CITY OF PORTLAND BUILDING PERMIT

has permission to Reconstruct 3 family after fire, change roof to gable, NOT TO FINISH 4TH FLOOR ATTIC - Storage only
provided that the person or persons, firm or corporation accepting this permit shall comply with all of the provisions of
the Statutes of Maine and of the Ordinances of the City of Portland regulating the construction, maintenance and use of
the buildings and structures, and of the application on file in the department.

RE: **15 Walton St 3 Unit**

In response to your comments we are providing copies of the elevations showing existing conditions and the proposed conditions and an overlay that illustrates the differences. The roof pitch is identical 10/12 to the existing. The roof has been modified replacing the existing hip roof with a gable roof.

Site Plan
1" = 30'-0"

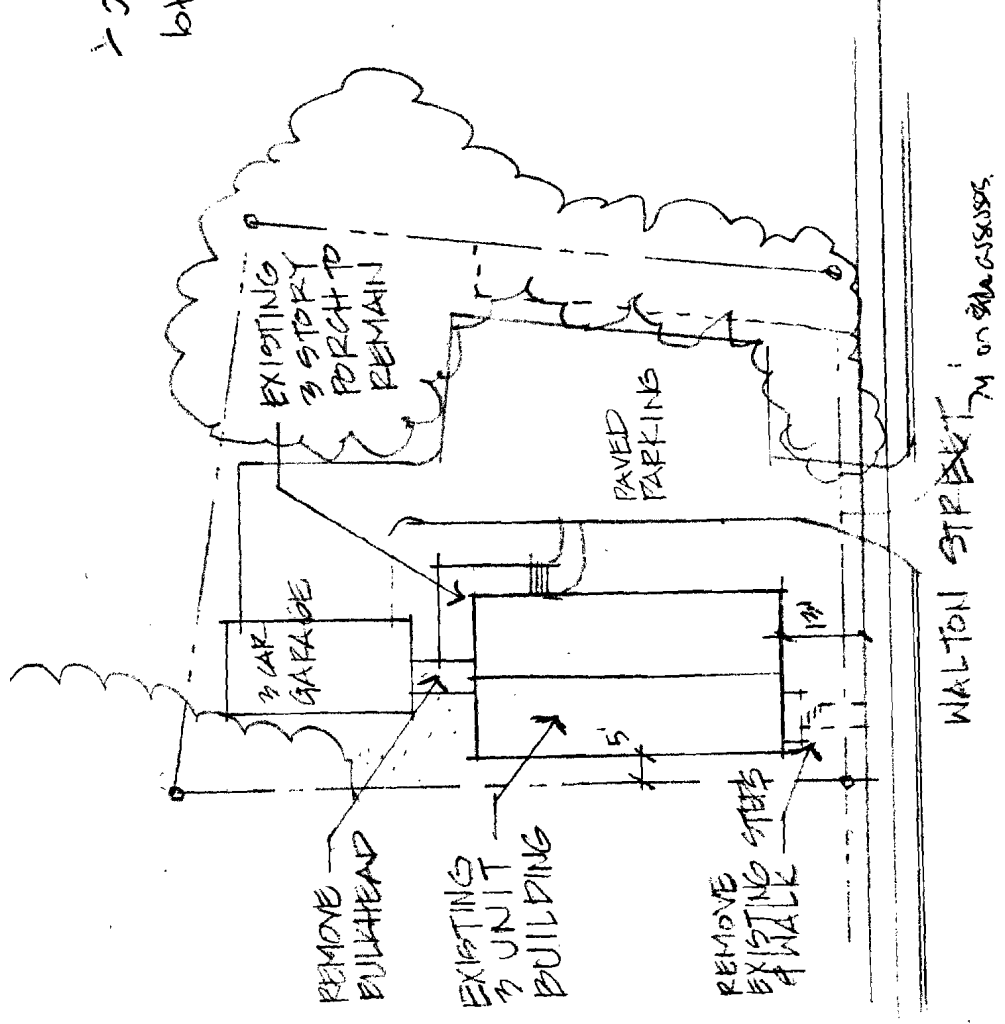
→ doesn't match
lot on assessor's
map.

STUDY
ELEVATION - FRONT
SCALE: 1/8" = 1'-0"

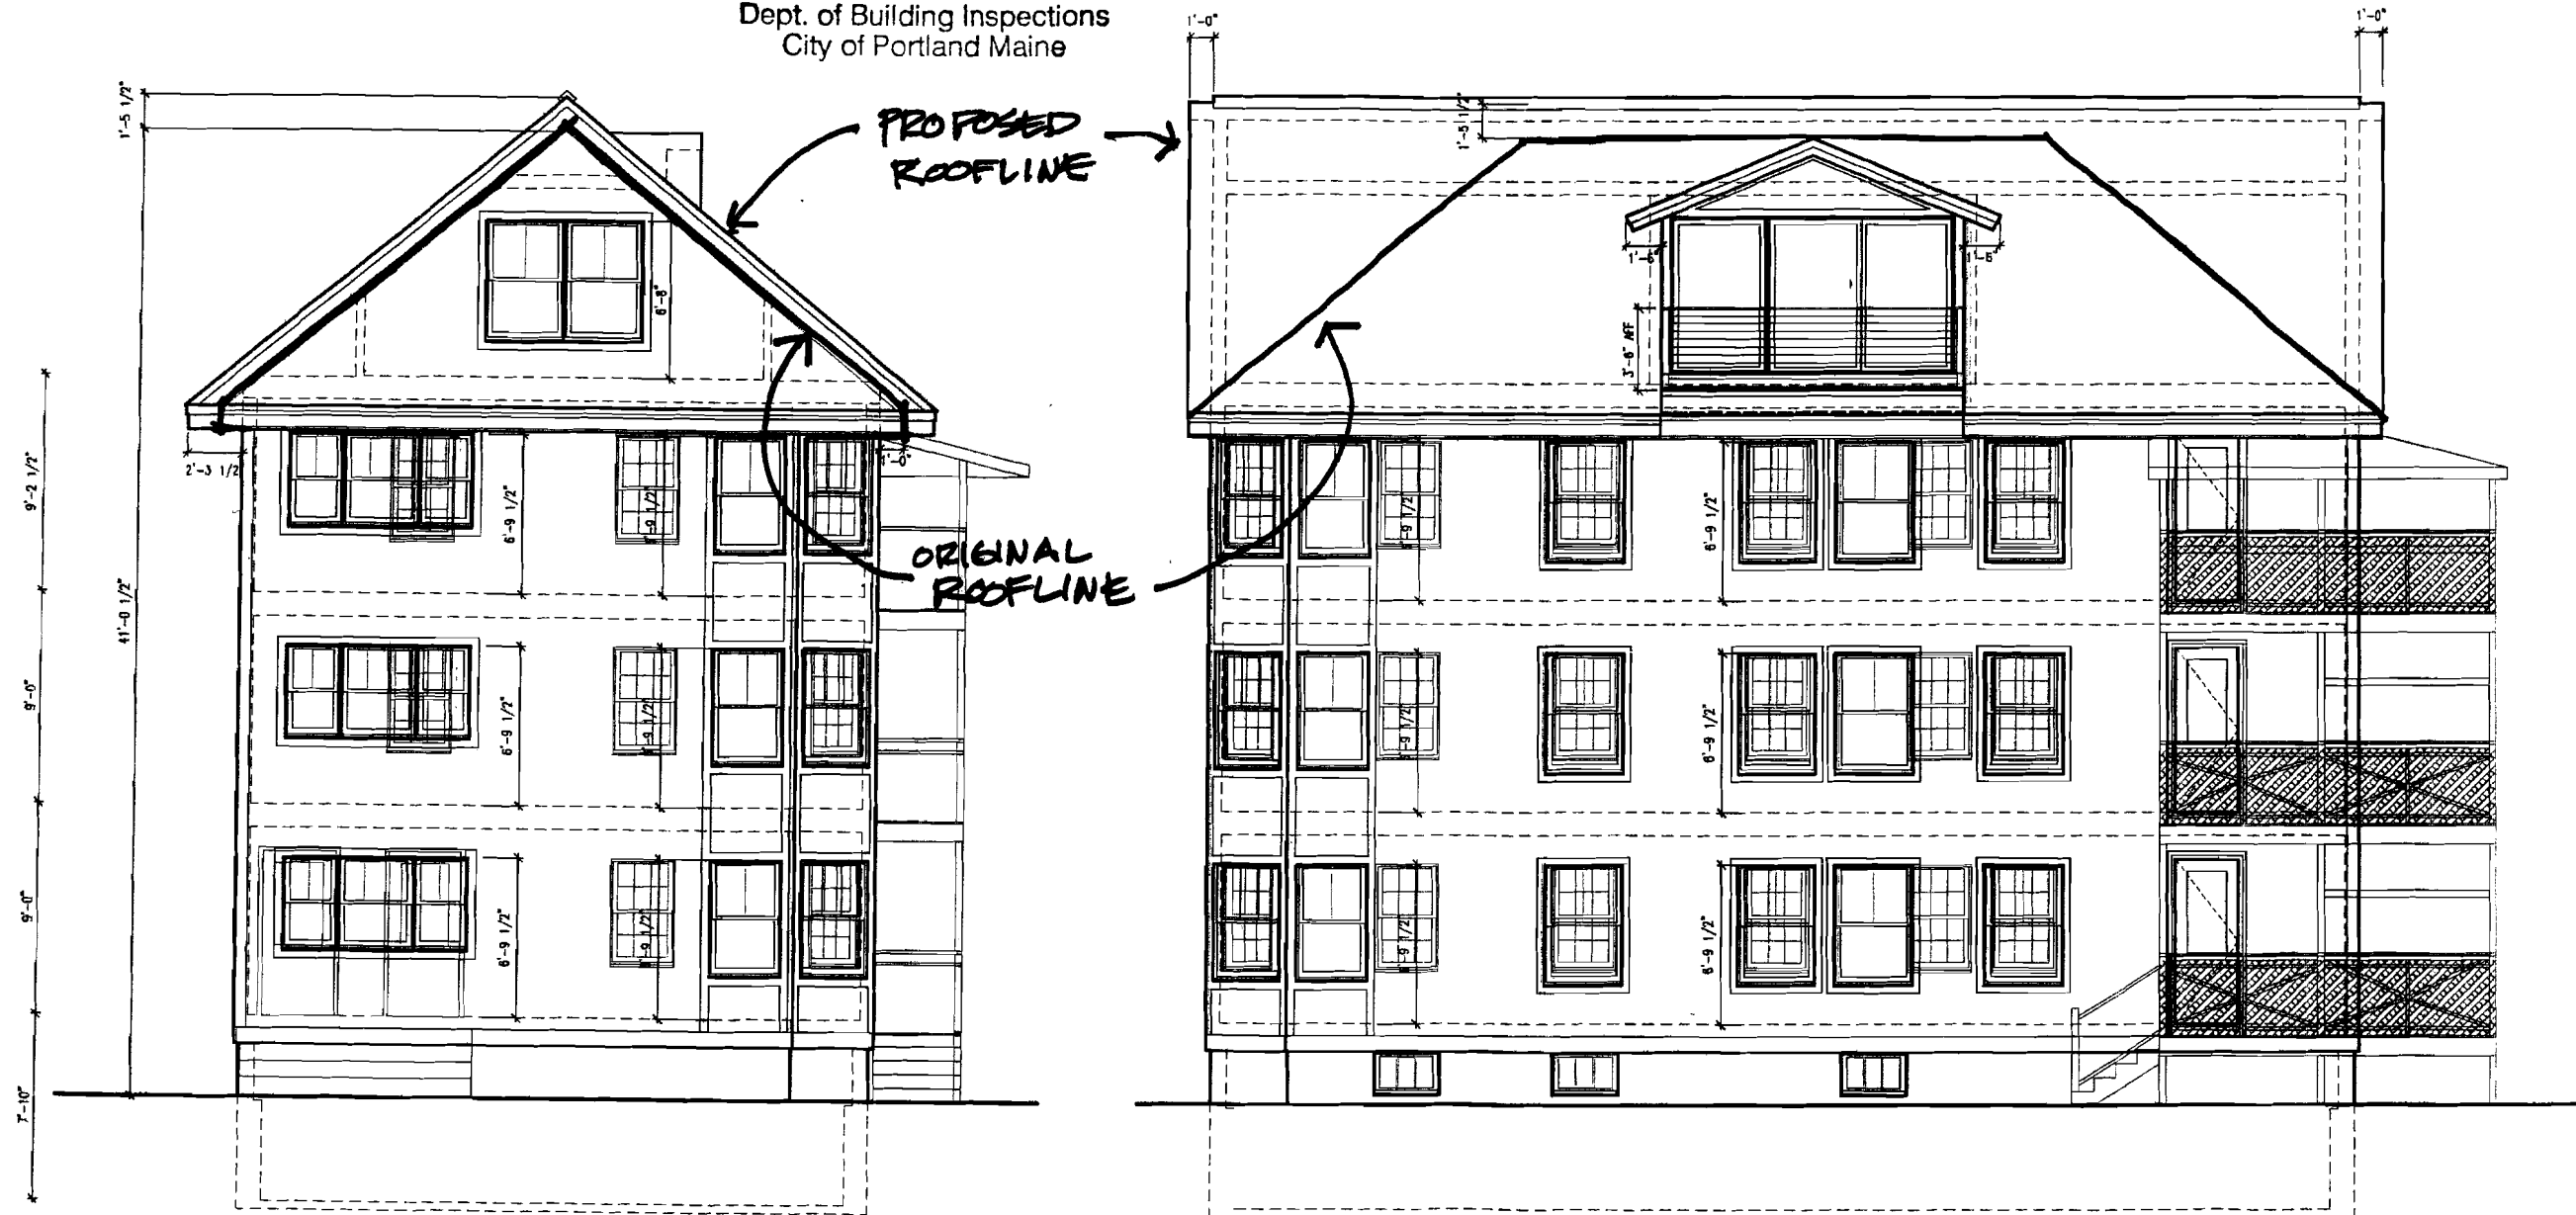
In response to your comments we are providing copies of the elevations showing existing conditions and the proposed conditions and an overlay that illustrates the differences. The roof pitch is identical 10/12 to the existing. The roof has been modified replacing the existing hip roof with a gable roof.

The attic floor had to be upgraded to meet 2009 IBC structural requirements from 2x6 @ 18" o/c to 2x10 @ 18" oc raising the ridge +/- 4". Further the existing 2x6 attic floor was toe nailed into the sides of the wall studs. Modern framing practices call for a floor platform to be built on top of the stud wall (not toe nailed into the side) which raises the ridge an additional 10". Finally the roof rafters have been upgraded to meet 2009 IBC structural requirements from 2x6 @ 24" to 2x10 @ 16" oc which adds another 6" due to the 10/12 pitch of the rafters. In total the ridge is raised 1'-5 1/2" above the original roof line due to structural considerations.

The current roof overhangs are +/- 12" on four sides. In order to align the fascia with the structurally modified roof rafters the overhang was increased to 2'-3 1/2" on the two long sides of the building while the gable ends remain at 12" overhang. If we need to reduce the overhangs on the long sides of the building to 2'-0" maximum we can revise the drawings accordingly.

A 5/12 pitch dormer was added on the parking lot side to properly shed water off the roof deck.
